**STAFF REPORT**  
**COMMUNITY DEVELOPMENT DEPARTMENT**

HEARING DATE: 8/11/2020  
 TO: Mayor & City Council  
 FROM: Joe Dodson, Associate Planner  
 208-884-5533  
 SUBJECT: H-2020-0035  
 Poiema Subdivision  
 LOCATION: The site is located at 3727 E. Lake Hazel Road, in the NE ¼ of the NW ¼ of Section 4, Township 2N., Range 1E.

Annexation & zoning of 14.87 acres of land with an R-15 zoning district and preliminary plat consisting of 48 building lots and 6 common lots, by Dave Evans Construction.

B. Master Development Concept Plan

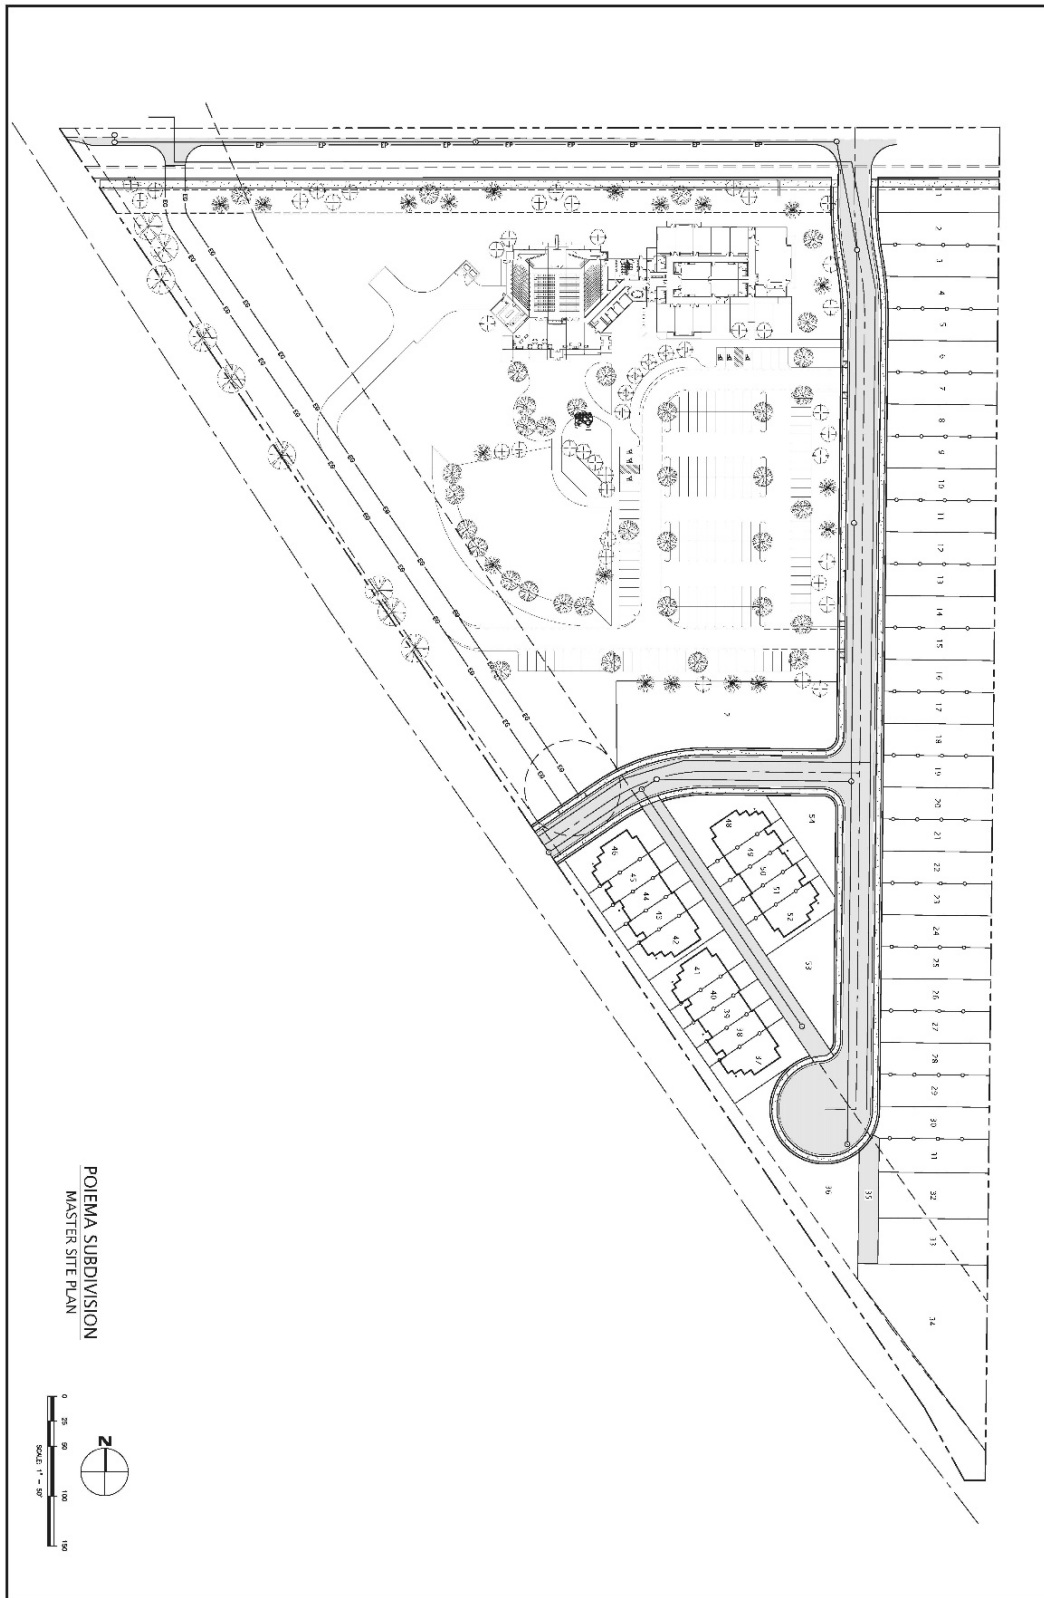
*Because the stub street to the west will likely lead to nowhere at the time of this development, the Applicant will have to provide an emergency only access. The Applicant is showing on their master plan (as shown in Exhibit VII.B) a 20-foot wide emergency only access from the stub street that runs along the western property boundary and connects to E. Lake Hazel. ACHD and Meridian Fire Department have granted their approval of this emergency access. Without this*

D. REVISED Plat (dated: 06/15/2020-7/30/2020)

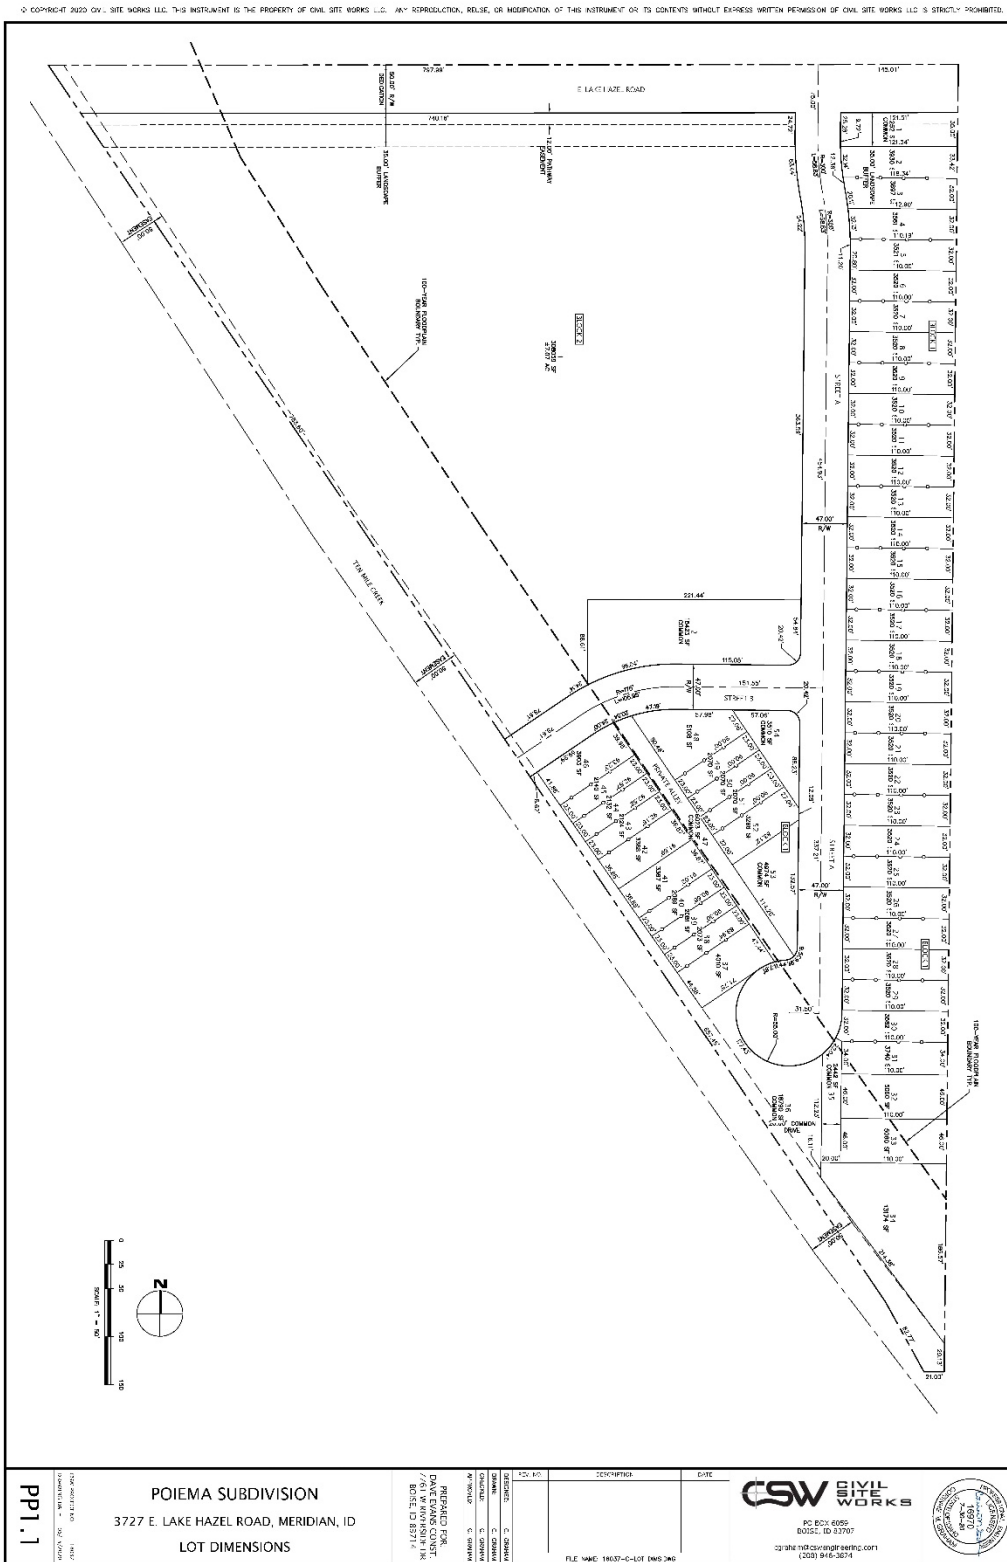
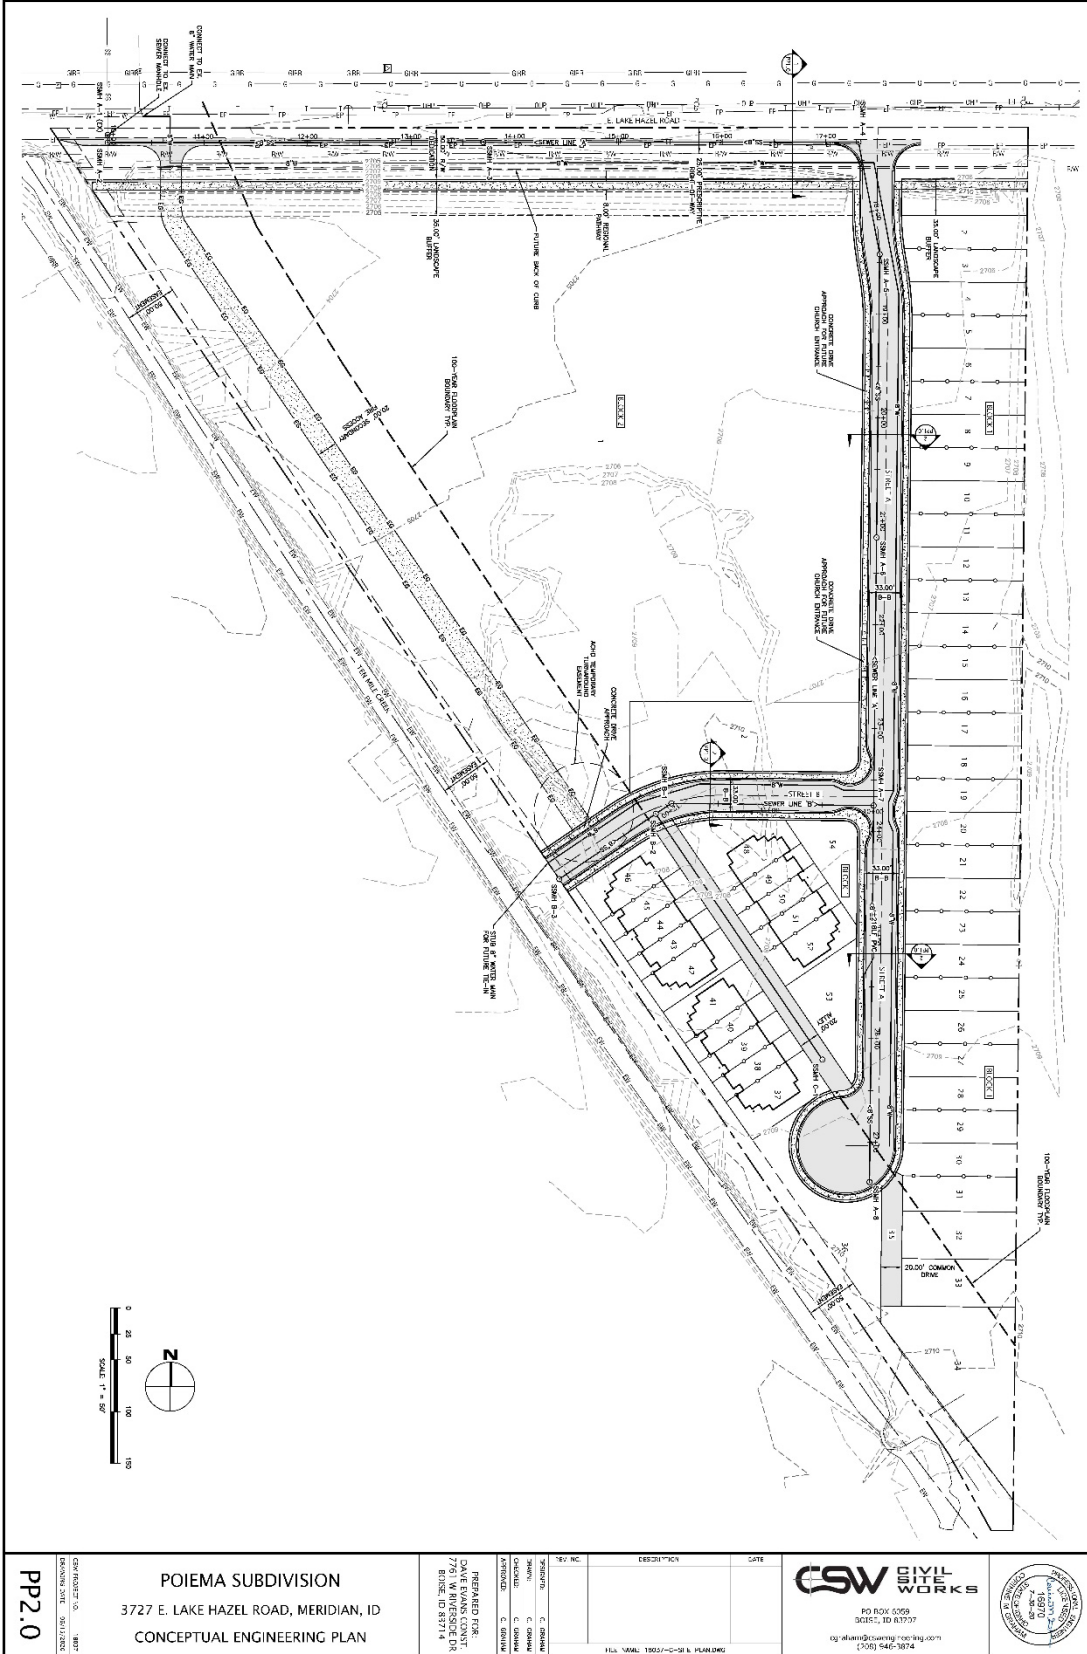
*The revised preliminary plat shows a private alley that connects to the future western stub street and the proposed cul-de-sac. As stated above, Staff is unaware of ACHD's formal approval of this location but has also not been given notice of its denial. The Applicant should continue working with ACHD to ensure the location of the alley meets all ACHD requirements. The proposed alleyway is shown as 20 feet wide which meets UDC and Fire requirements; the alleyway will be deemed as a no parking zone for its entirety. Staff supports this alleyway and the alley loaded type of home for this development.*

3. ~~Ten (10) days prior to the City Council hearing, the~~ The revised preliminary plat included in Section VII. CD, dated 04/15/2020 July 30, 2020, shall be revised as follows is approved as submitted.

E. Open Space Exhibit (dated: ~~06/15/2020~~ August, 2020)

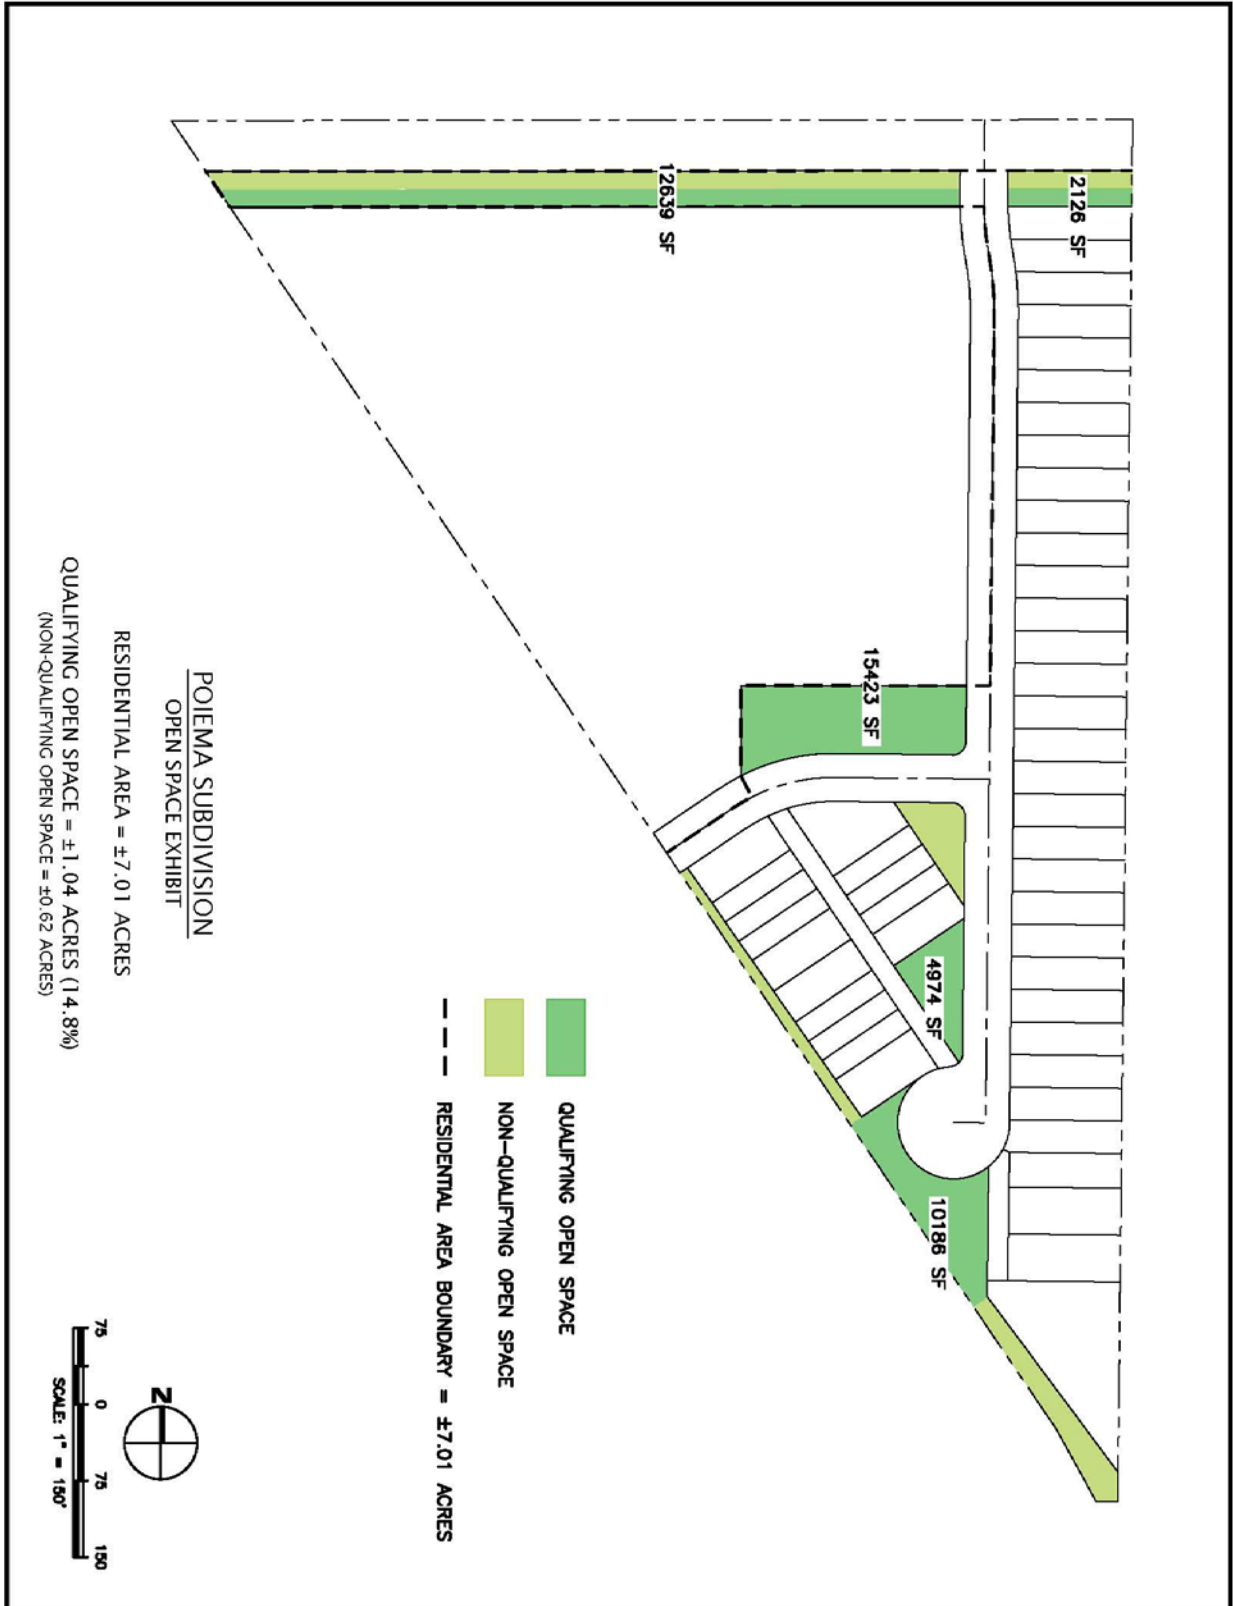
On the revised open space exhibit (Section VII.E) there is an area less than 5,000 square feet located between the alley and the local street. UDC requirements state that in order for this area to be qualifying it must be at least 50’ by 100’ in dimension. Staff uses their discretion when the open space area can meet the 5,000 square foot area requirement but may not meet the precise dimensions above. In this case, this area meets neither of these benchmarks and Staff believes it is not qualifying open space. With this area removed from the open space calculations, Staff has calculated that the qualified open space for the site is approximately 0.64 acres, or approximately 10.57%. The proposed open space still meets UDC minimum requirements and Staff finds that the open space with the water feature and the large open space lot in the center of the development are sufficient for the number of homes proposed in this development.

The required landscape buffer along E. Lake Hazel should be shown on the open space exhibit even though it is not qualifying open space. As stated above, Staff recommends these improvements be completed with development of the residential portion of the site. The open space exhibit should be revised to show this area to give a more complete picture of all open space on the site in accordance with UDC 11-3G-3.

5. ~~Ten (10) days prior to the City Council hearing, the open space exhibit included in Section VII.E shall be revised to show the required 35 foot landscape buffer along E. Lake Hazel and show this area in the calculations table.~~

G. Conceptual Building Elevations

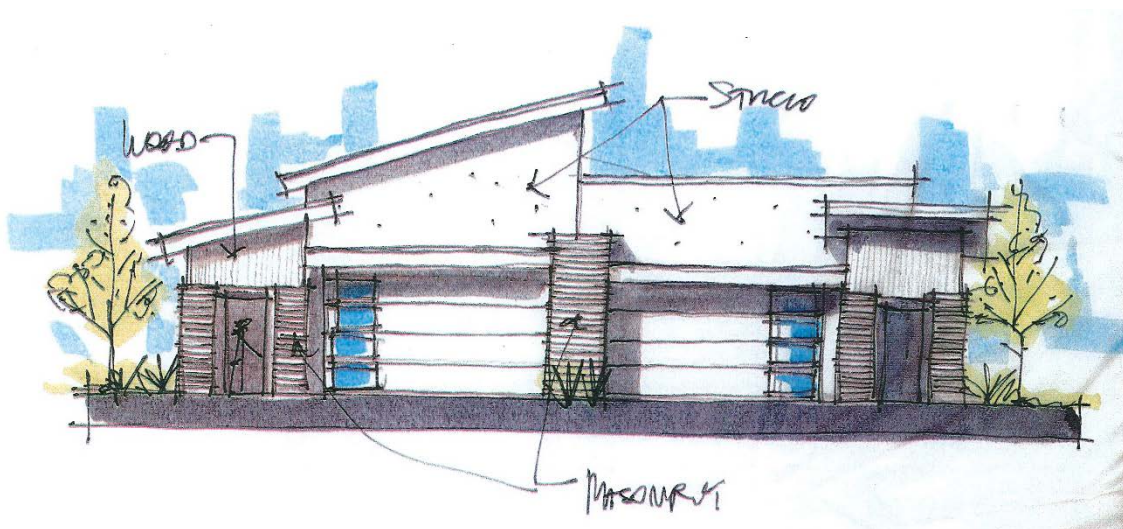
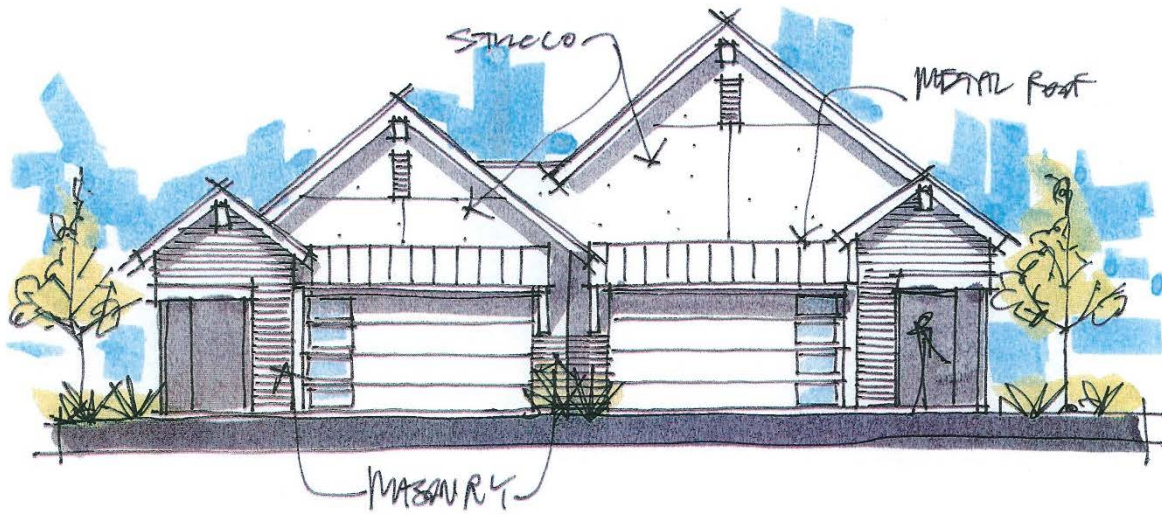
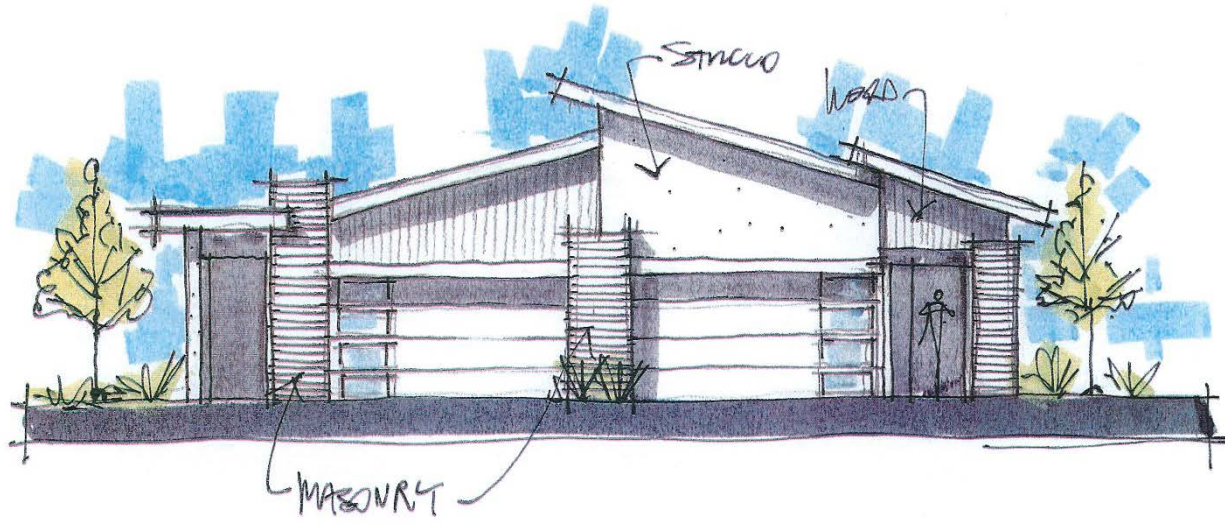
The Applicant has submitted sample elevations of the attached single-family homes for this project (see Section VII.G).

*The submitted elevations show all single-story attached structures with two-car garages and similar finishing materials of stucco, masonry, and wood. In addition, the elevations show both shed roof and traditional pitched roof designs. The Applicant has not stated there will only be single-story attached structures. Staff has also not received updated elevations for the townhome style product. The submitted sample elevations appear to meet design requirements for single-family homes.*
